SEPTIC PERMIT

ON-SITE SEWAGE DISPOSAL SYSTEM HOWARD COUNTY HEALTH DEPARTMENT BUREAU OF ENVIRONMENTAL HEALTH

**RE: Plan Approval for Conventional LPD, Biggins Property, Clarksville Ridge, Lot 44
6726 Surrey Lane, Clarksville, MD 21029**

Approved Septic System Plan
Howard County Health Department
Pretreatment & L.P.D.
Repair approved as shown, Sheets 1 to 16
[Signature] *9/1/2009*
Signature Date

SHEET: 10 OF 16

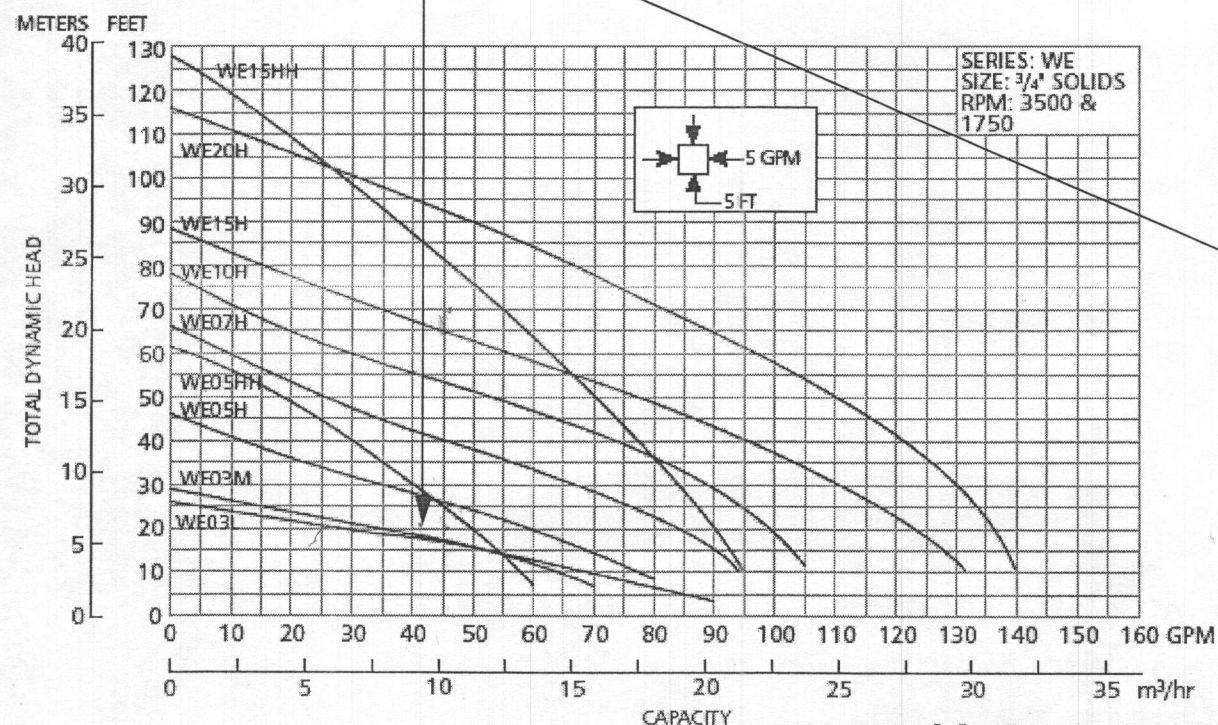
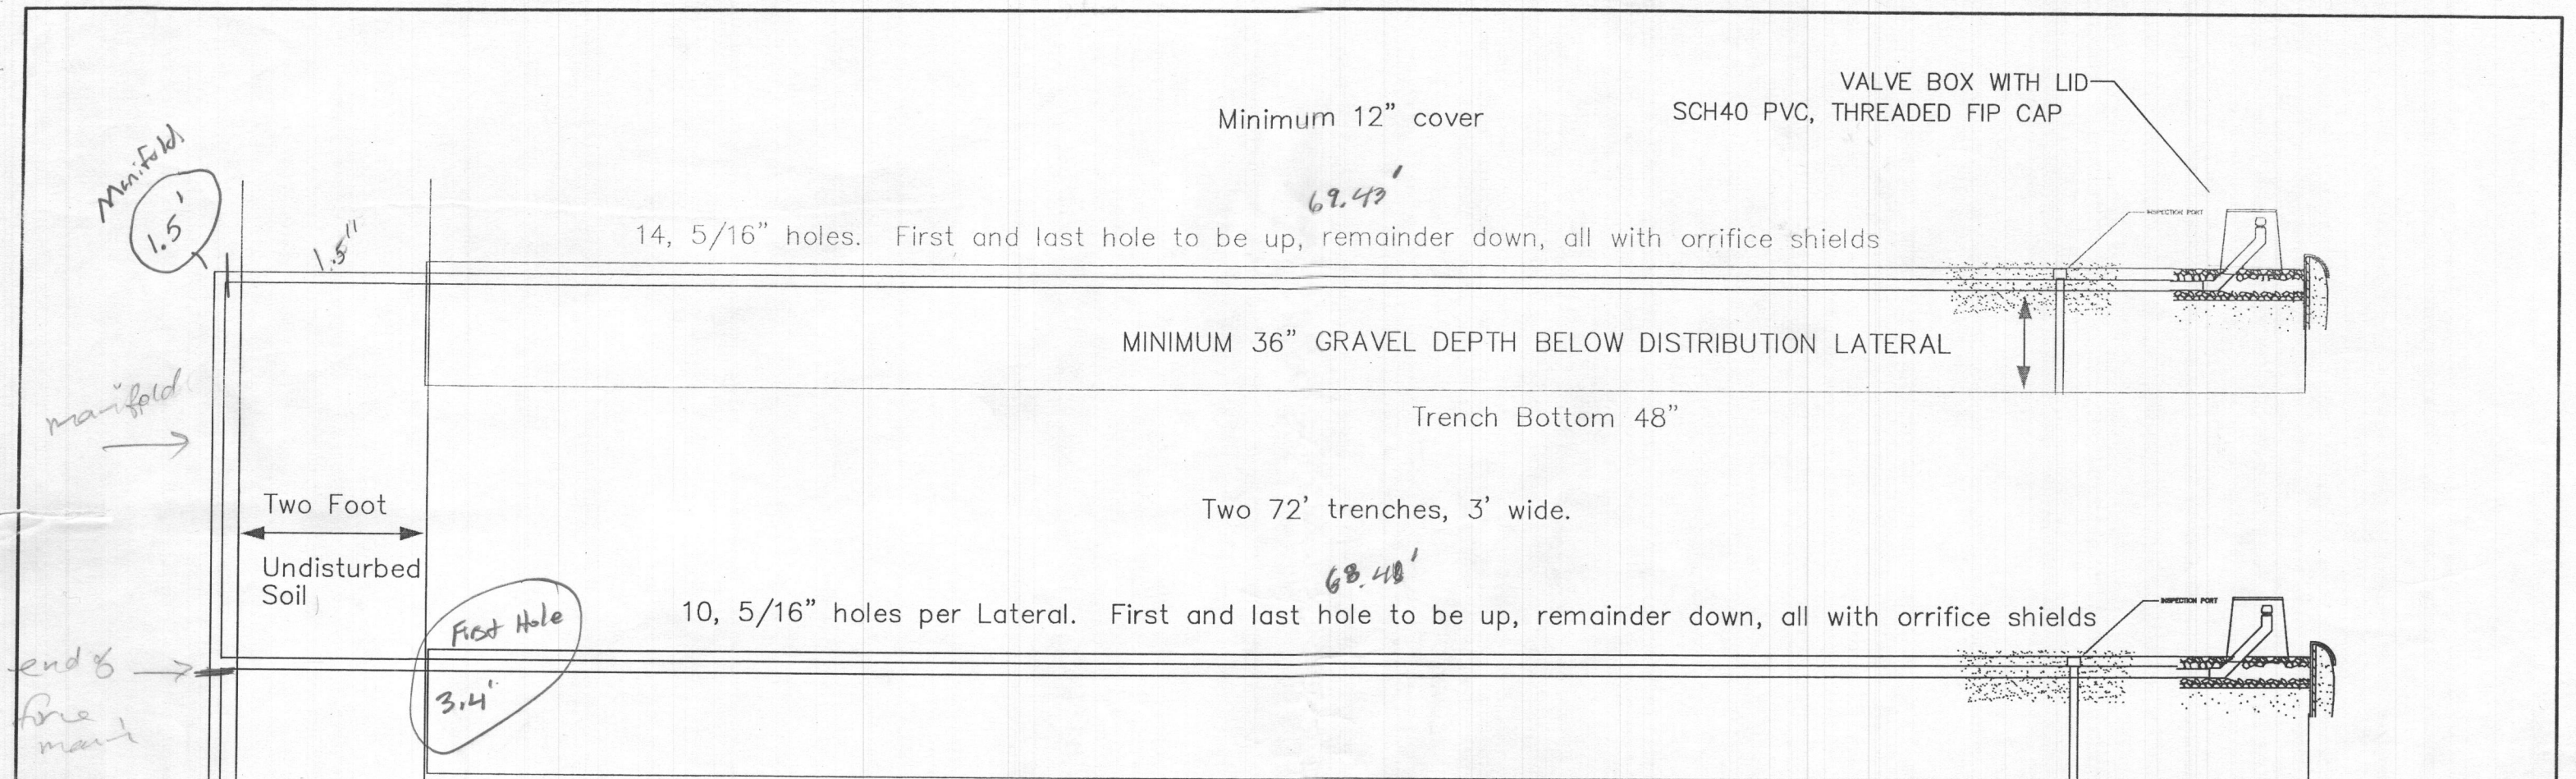
Plan clarifications include the following: refer to sheets 3,7,8,10 & 11. Force main is 2" in diameter, 8 ft manifold is 1.5" in diameter, laterals are 1.5" in diameter with 5/16" holes with first and last holes in laterals drilled facing upward, orifice shields must be installed, trenches must have observation pipes, lateral turnups are to be sleeved, 3/4" washed gravel is to be used. Corrections to the plan to be noted include Sheet 7 (Item 4): System flow is 46.43 gpm at 22.47 ft of head as indicated on Sheet 10 and not 33 gpm. Sheet 7 and 8 (Item 6 & 8): There are no valves on the force main, manifold or laterals. Further plan clarification may occur during the preconstruction meeting with the contractor and the designer present
